Lime Down

Solar Park

Change Application and Consultation Report (Change Application)

Document Reference: EXAM/9.40

Title:
Works Plans Comparison
- Change 3.2

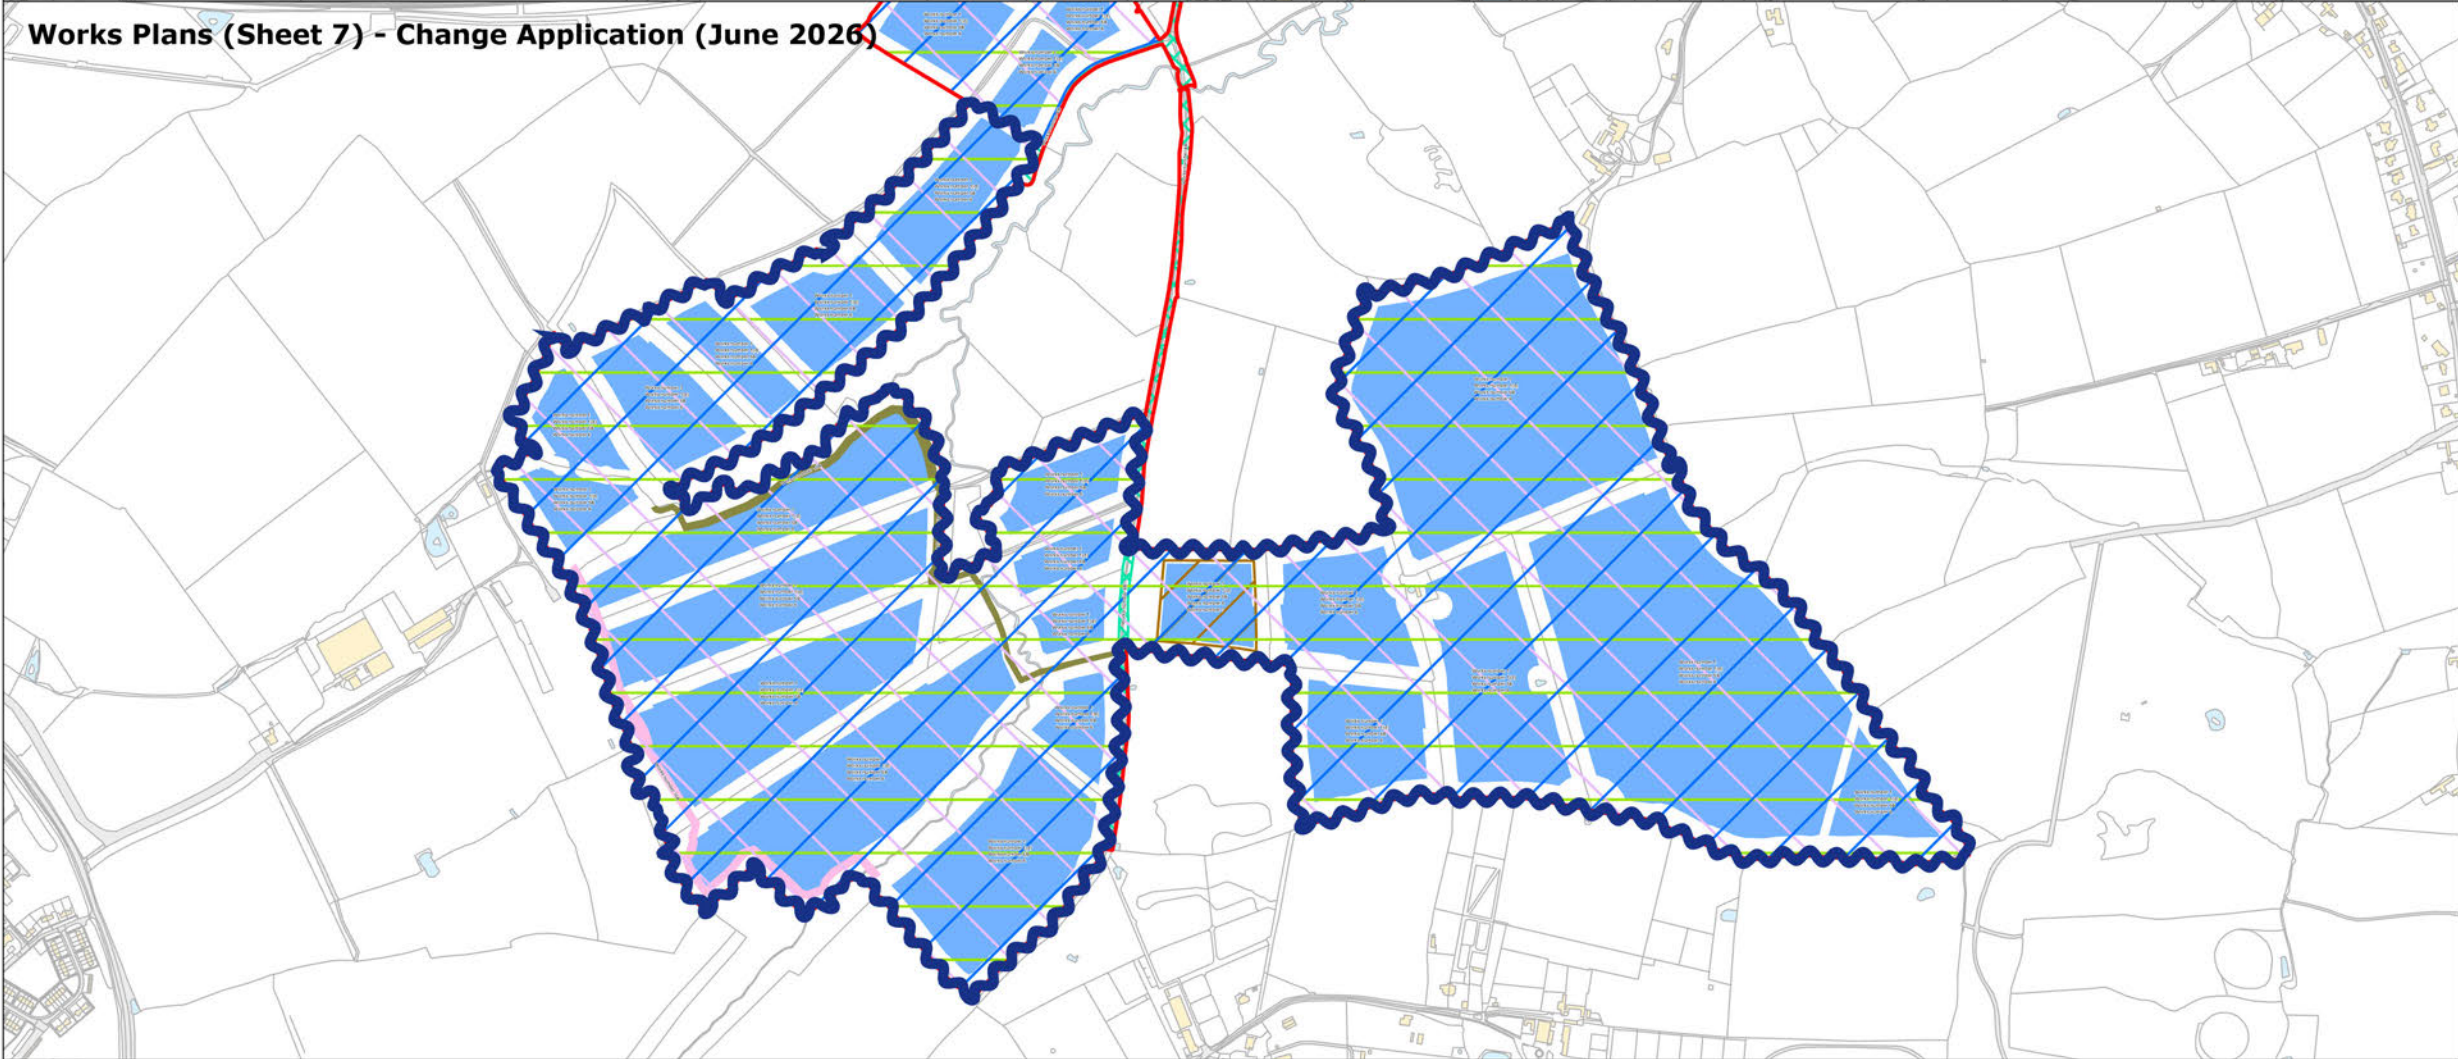
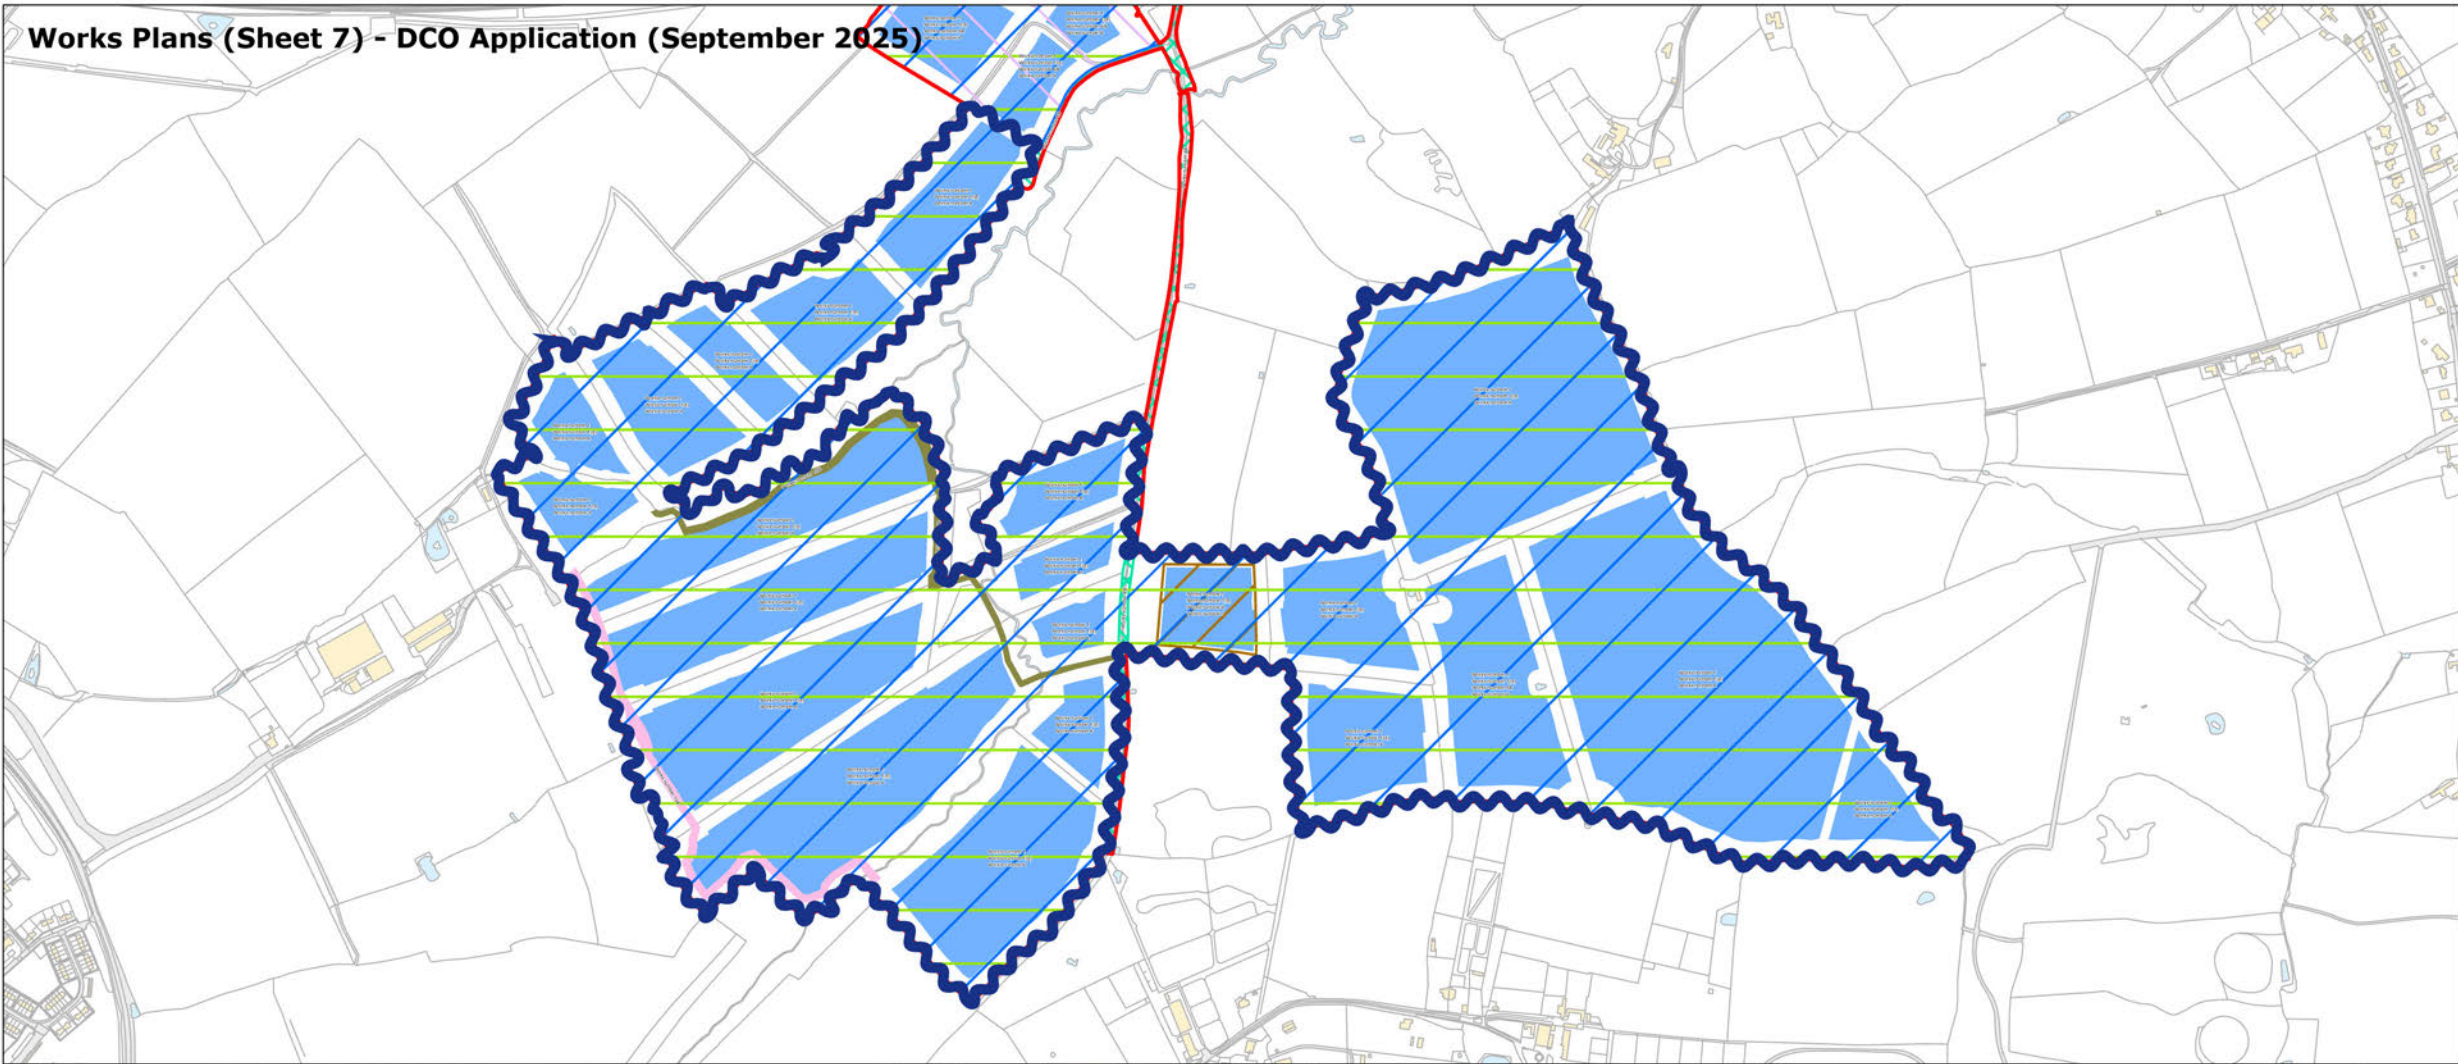
Change 3: Update of the Works Plans to allow more flexibility in the detailed design of the interconnecting cable alignment

- 3.1.10 Change 3 comprises an update to some areas within Lime Down A, C and E to include Work Number 5B (electrical cables up to 132 kV (referred to as interconnecting cables in Table 3-1 in **ES Volume 1, Chapter 3: The Scheme [APP-055]**)) in addition to Work Number 1(d) (electrical and communications cabling (referred to as on-site cables in Table 3-1 in **ES Volume 1, Chapter 3: The Scheme [APP-055]**)).

- 3.1.11 The area comprising Work Number 1(d) allows for electrical and communications cabling within the Solar PV Sites, and some areas of Work Number 1(d) already include areas of Work Number 5B, however incorporating Work Number 5B across the entire area of Work Number 1(d) allows for more flexibility at the detailed design stage in the routing of the interconnecting cables between the Conversion Units, 33 kV Sub-distribution Switch Rooms, 132 kV Substations, 400 kV Substation and the Solar PV Sites. The plan provided shows the additional area in Lime Down A (Change 3.1), Lime Down C (Change 3.2) and Lime Down E (Change 3.3) where the Applicant is seeking to include Work Number 5B in addition to Work Number 1(d).

Title:
Works Plans Comparison
- Change 3.3

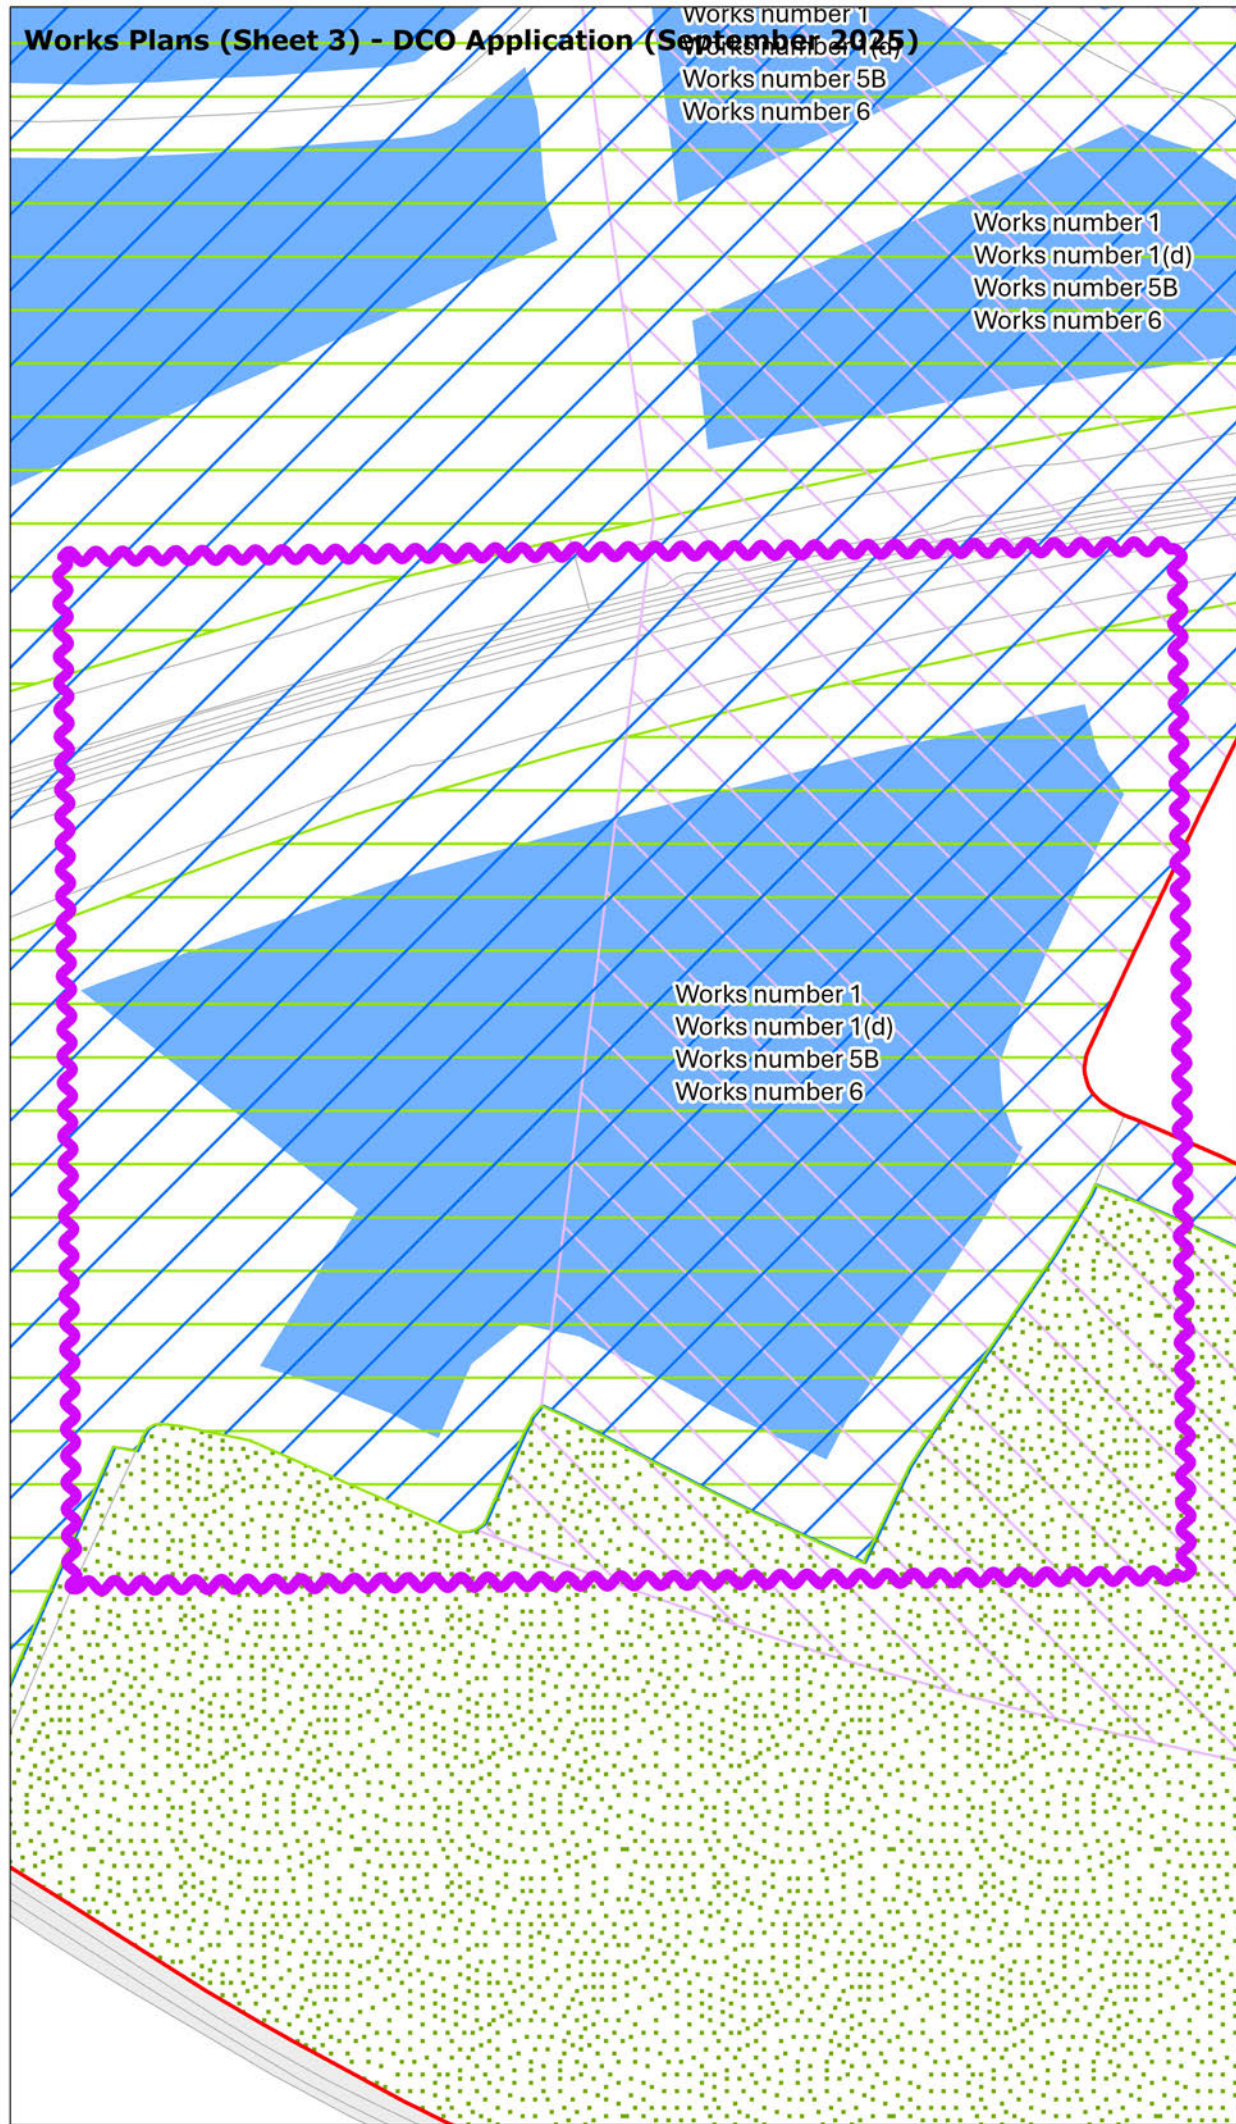
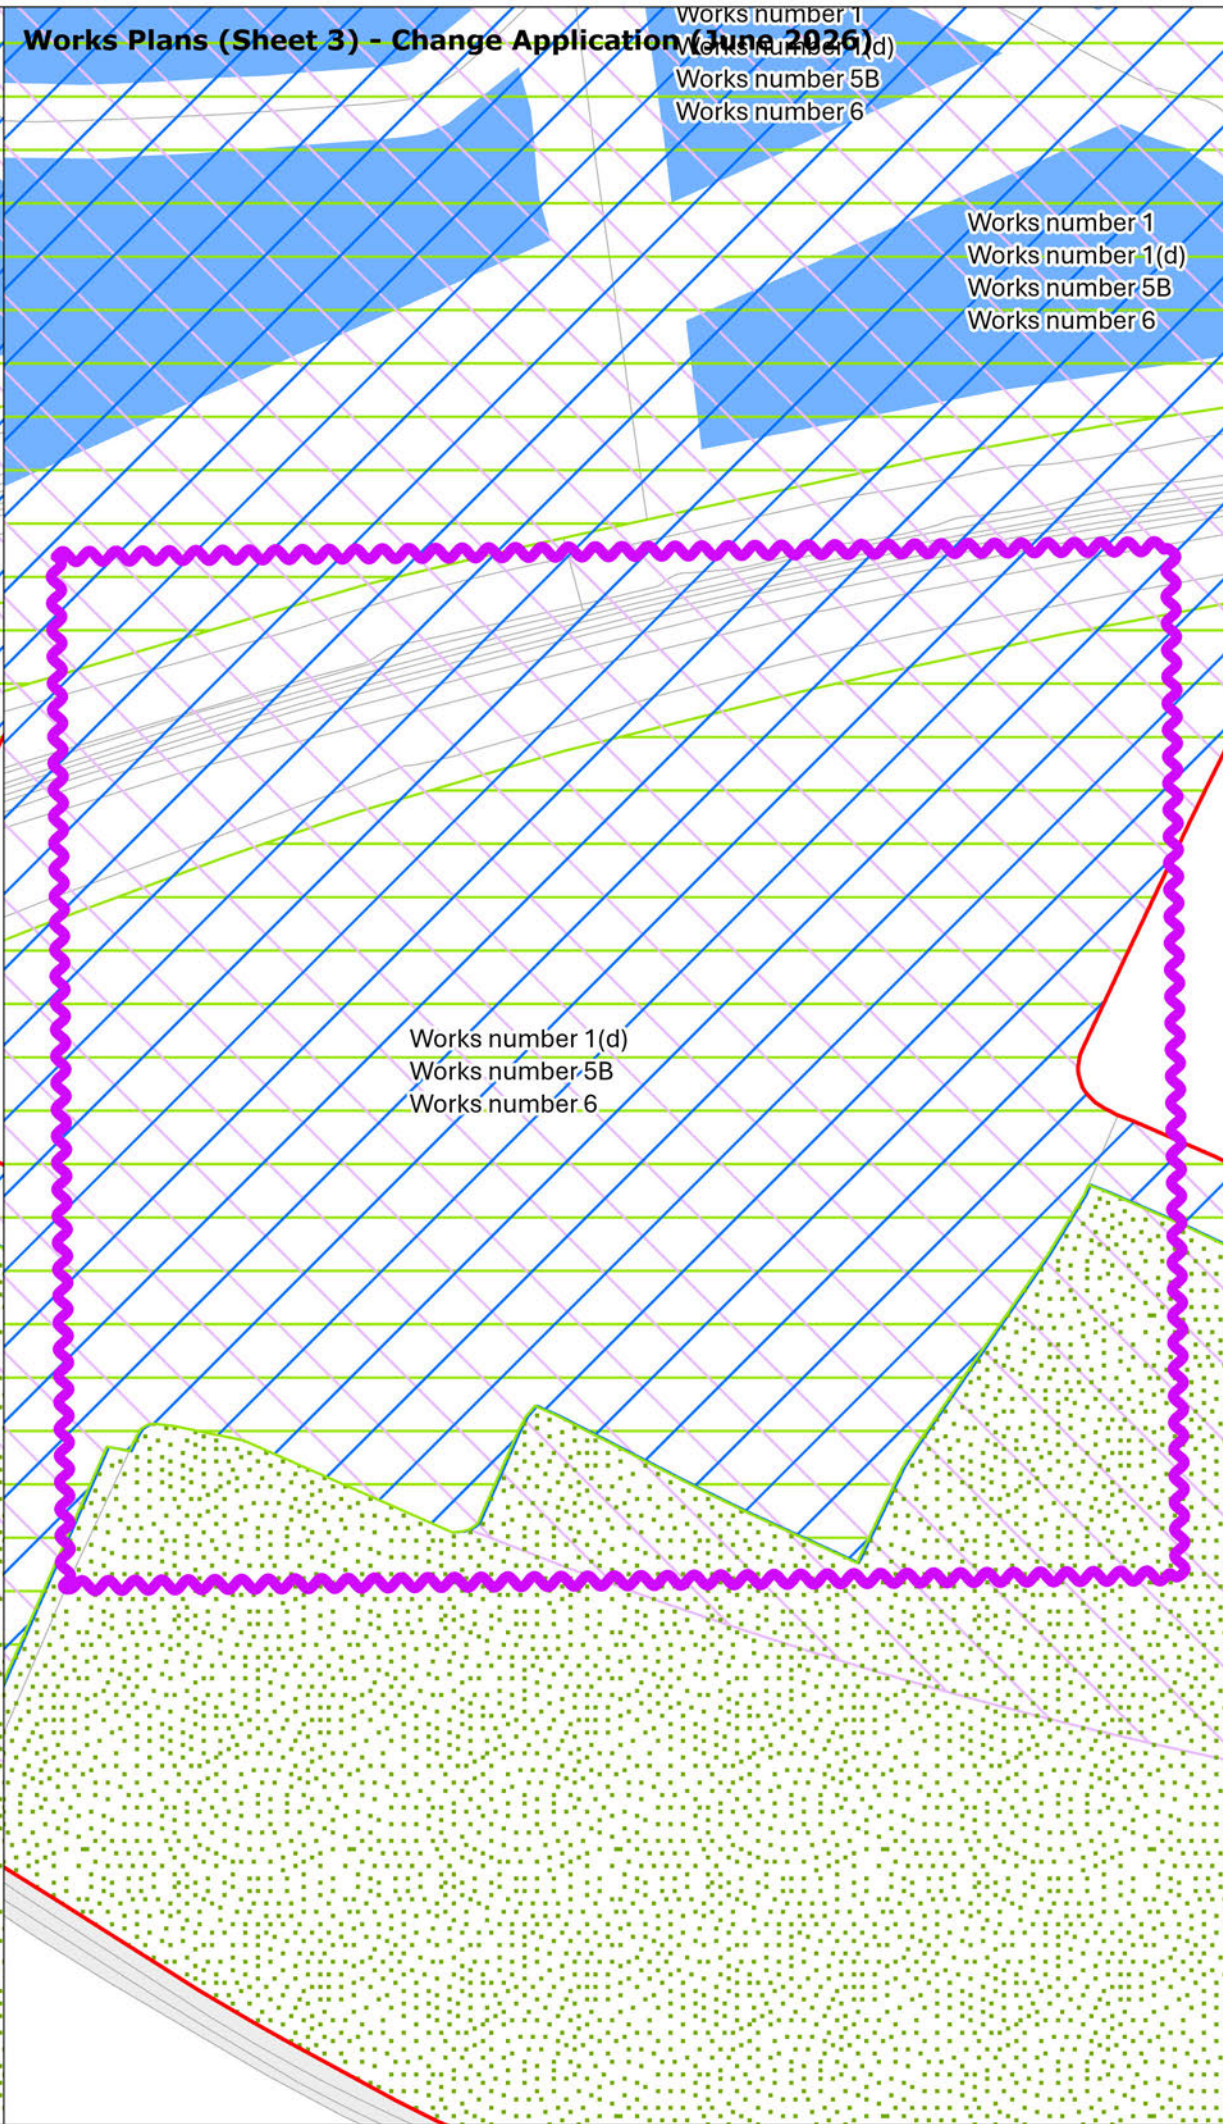
- 3.1.12 All cabling will be underground, and subject to the parameters stated in **Design Principles and Parameters [REP3-083]**. There is no change to the extent of the Order Limits associated with Work Number 5B being included in addition to Work Number 1(d). Change 3 allows for the interconnecting cables to be laid in the same location as on-site cables, where possible, including the design flexibility to place both interconnecting cables and on-site cables into a single trench.
- 3.1.13 The **Works Plan [EN010168/APP/2.3] [Change Application]** has been updated to reflect Change 3.
